Operable Unit C

Final Feasibility Study Report

Fort Richardson, Alaska

September 1997

Figure 3

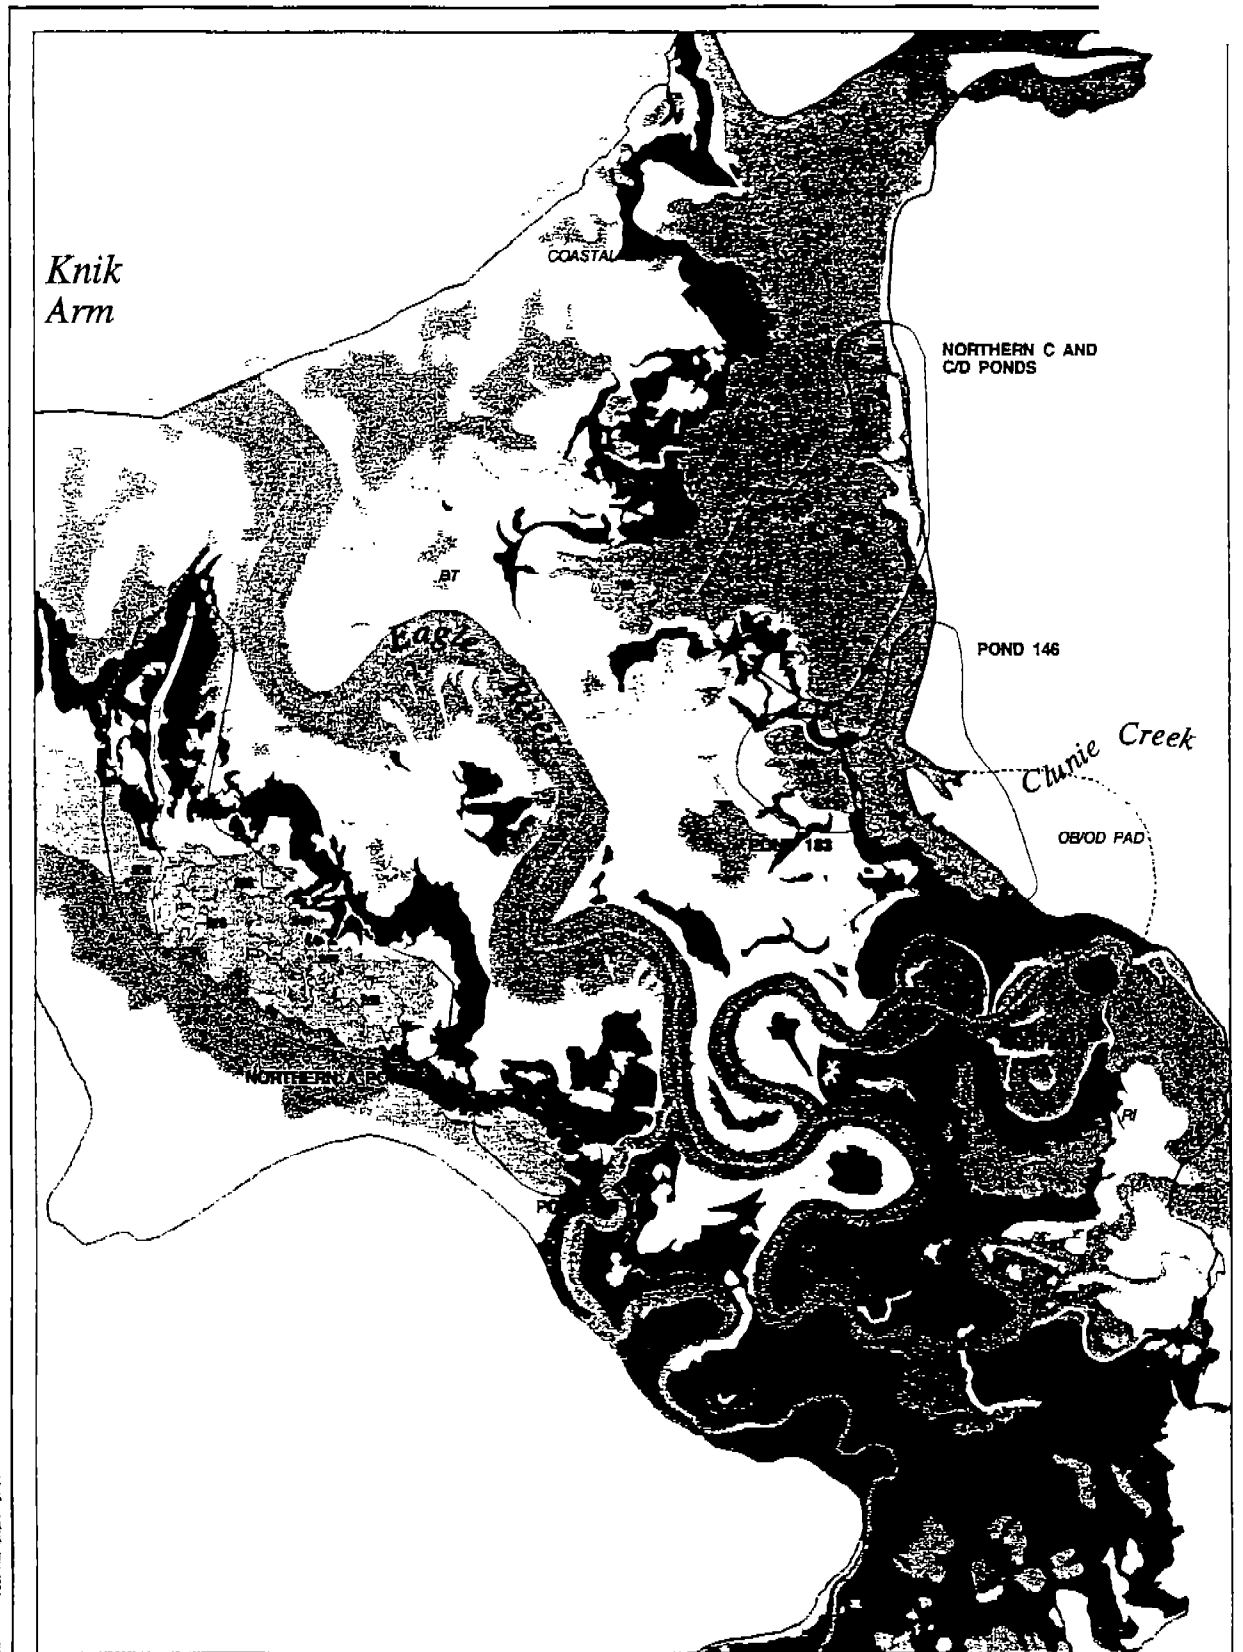
2-9 Figure 3: Use a fold-out map like Figure C-1. Print is too small to read.

Figure A-1
Average Daily Weather Information at Elmendorf AFB
 Operable Unit C
 Feasibility Study
 Fort Richardson, Alaska

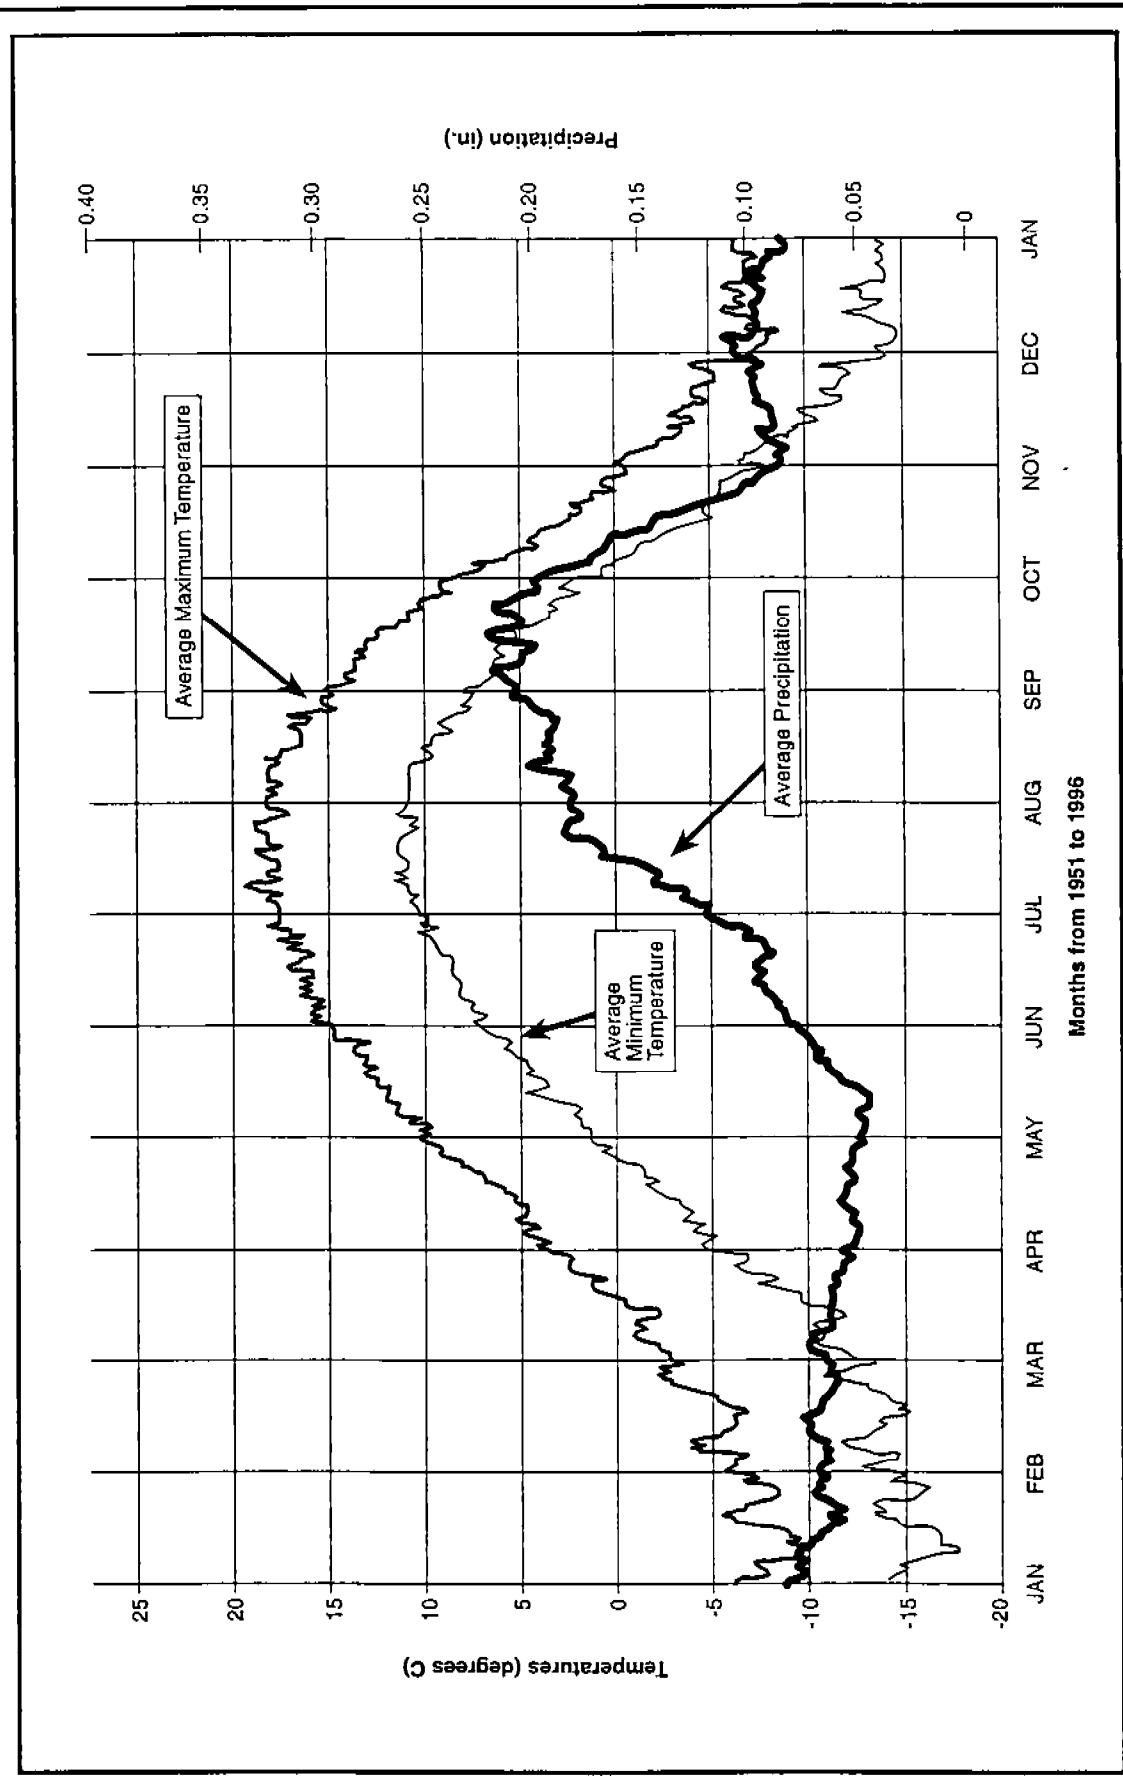
54	A-7, Sec. 2.5, 2nd Para.	<i>A much higher, unmeasured, peak...</i>	The flow rates and reference provided in the comment have been used to update the text. The information provided in the comment is appreciated.
55	A-6, Figure A-1	<i>Can axes be labeled with °C and mm to...</i>	The units of the axes have been converted to the metric system.
56	A-9, Figure A-2	<i>There are two arrows for Coastal 6 gully.</i>	The two arrows are intentional.
57	B-4, Para. 5	<i>Unit cost vs. Length applies only to...</i>	The text has been revised to clarify that unit costs apply only to breaching.
58	B-4, 2.1.2	<i>Need to include cost of blasting sump for...</i>	The following statement was added: "Cost of blasting a sump for the pump was not included."
59	B-6, 2nd	<i>It was assumed that only one operation...</i>	Agreed. Only one drying season was assumed for the order-of-magnitude cost estimate. However, it was stated in the text that it is likely that longer seasons will be needed. Therefore, in the budget-level cost estimates in Appendix E, a five-year implementation period was assumed for Alternatives 3 and 4.

Figure A-2

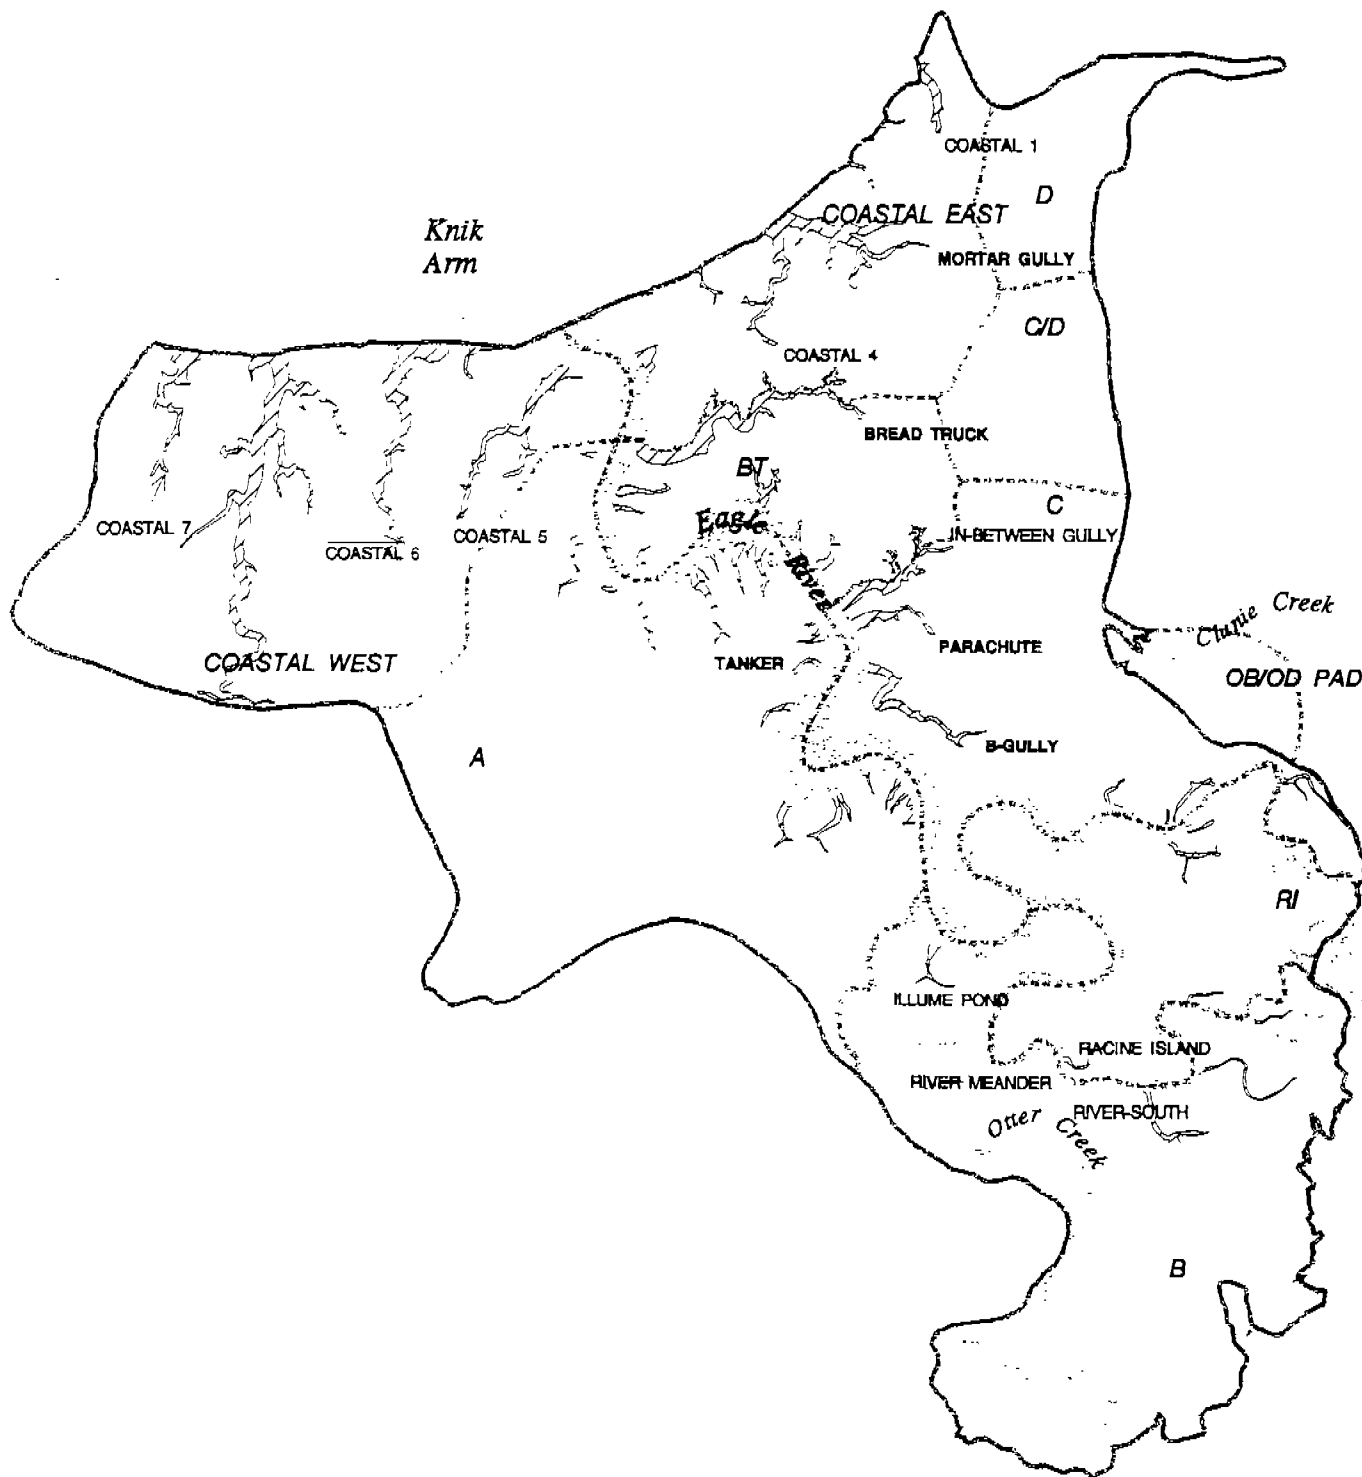
6. Page A-9, Figure A-2 --

A-9 Figure A-2: There are two arrows for Coastal 6 gully. (MRW)
